# Service Bulletin

Bulletin No.: 16-NA-190

**Subject: Radio Volume and Tune Knobs Broken, Missing or Will Not Stay Attached**

| Brand:    | Model:         | Model Year: |      | VIN: |    | Engine: | Transmission: |
|-----------|----------------|-------------|------|------|----|---------|---------------|
| Chevrolet | Impala (VIN 1) | 2014        | 2017 |      |    | All     | All           |

4533361

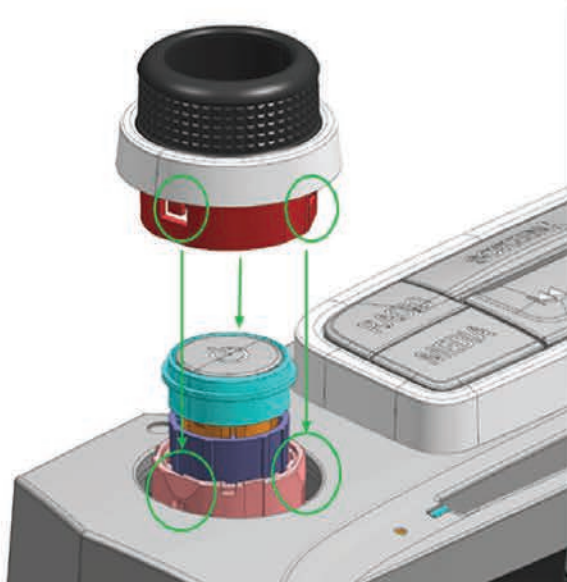
| <b>Condition</b>                  | Some customers may comment the Volume and/or Tune knob is broken, missing or will not stay attached to the control assembly.                                      |
| <b>Cause</b>                      | The cause of the condition may be improper retention of the original knobs, which can be removed.   |

To prevent damage during installation, make sure the orientation of the knob is as shown in the illustration above. The three clips on the knob should align with the three retention features on the control assembly. No added force should be needed to turn the knobs, if the parts are installed properly.

**Important:** DO NOT replace the entire control assembly for this concern.

Replace the affected Volume and/or Tune knob(s) with service kit listed in the parts table below.
